**Addendum to the  
Environmental Assessment of Statoil's  
Geophysical Program for the Jeanne d'Arc and Central  
Ridge/ Flemish Pass Basins,  
2011-2019**

**June 2011  
LGL Project No. SA1121-1**

This addendum contains Statoil's responses to reviewer comments on the "Environmental Assessment of Statoil's Geophysical Program for the Jeanne d'Arc and Central Ridge/Flemish Pass Basins, 2011-2019". Comments and responses are organized by the regulatory agency and groups that submitted comments. Comments are provided in italic font and responses in normal font.

**Figure 1. Locations of NAFO Coral/Sponge Closure Areas relative to the Statoil Study Area, Project Area, and 2011 Proposed 3D Seismic Area.**

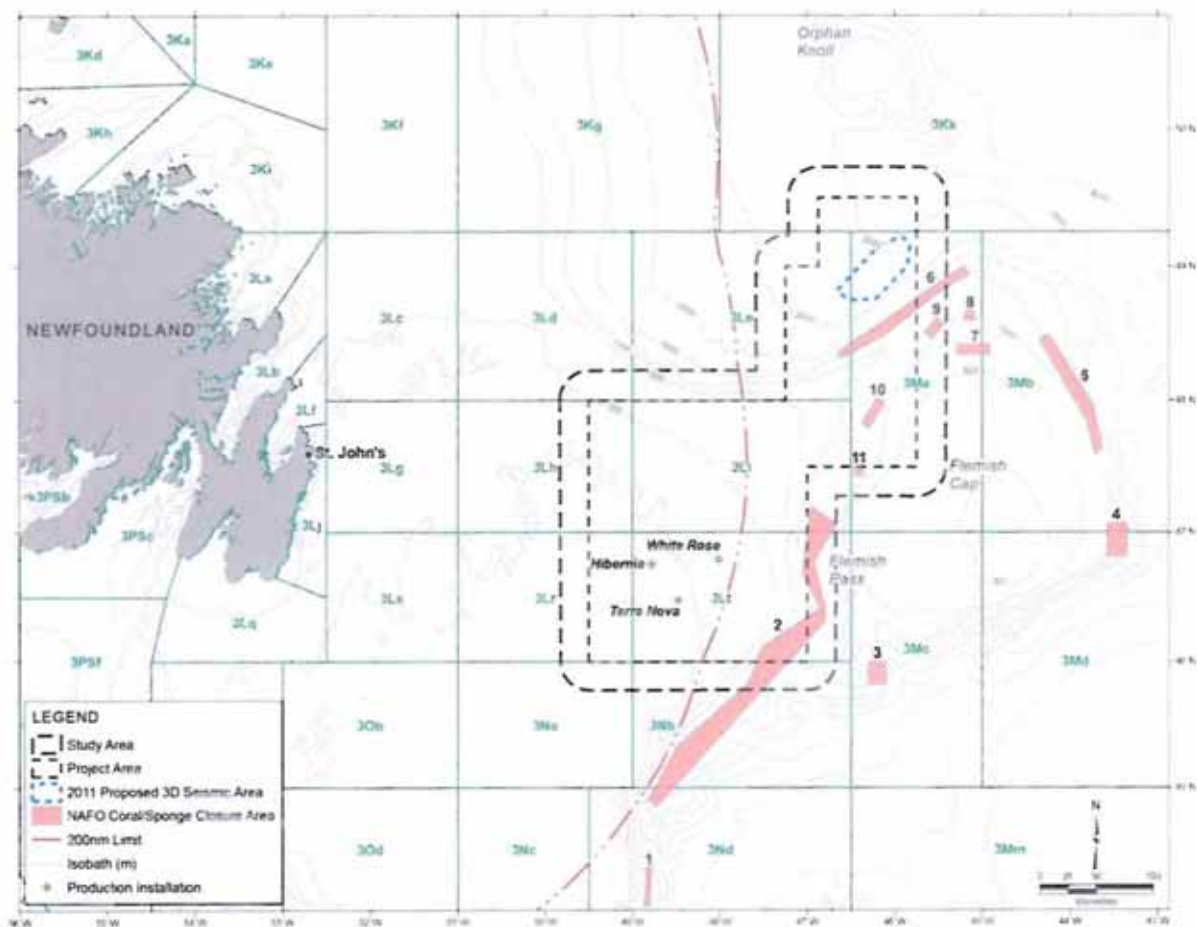
**General Comment:** Please be advised that DFO recommends that Statoil adhere to the "Statement of Practice with Respect to the Mitigation of Seismic Sound in the Marine Environment" (SOCP) when conducting seismic programs. The SOCP specifies the mitigation requirements that must be met during the Planning Seismic Surveys, Safety Zone and Start-up, Shut-down of Air Source Array(s), Line Changes and Maintenance Shut-downs, Operations in Low Visibility and Additional Mitigative Measures and Modifications in order to minimize impacts on life in the oceans. These requirements are set out as minimum standards, which will apply in all non-ice covered marine waters in Canada. Sensitive Areas should include areas that are considered vulnerable, specifically areas that are known to have coral and/or sponge. Please consider incorporating aspects of the following documents:

- "Status Report on Coral and Sponge Conservation in Canada" for context of coral/sponge conservation in NL waters. <http://www.dfompo.gc.ca/library/340259E.pdf> Sections: 3.2.2, 4.5, 7.2.1 as well as Figures: 1, 6, 7)
- Canadian Science Advisory Secretariat Science Advisory Report 2010/041 "Occurrence, Sensitivity to Fishing, and Ecological Function of Corals, Sponges, and Hydrothermal Vents in Canadian Waters" [http://www.dfo-mpo.gc.ca/CSAS/Csas/publications/saras/2010/2010\\_041\\_e.pdf](http://www.dfo-mpo.gc.ca/CSAS/Csas/publications/saras/2010/2010_041_e.pdf)
- NAFO Conservation and Enforcement Measures 2011 Article 16 "Coral and Sponge Protection Zones" <http://www.nafo.int/fisheries/frames/regulations.html>

Change the title of Section 4.2.4 to "Deep-water Corals and Sponges" and add the following text and figure to Section 4.2.4:

In 2008 and 2009, the NAFO Scientific Council identified areas of significant coral and sponge concentrations within the NAFO Regulatory Area. Based on these identifications, areas for closure to fishing with bottom contact gear were delineated (see revised Section 4.2.4 and Figure 1 above).
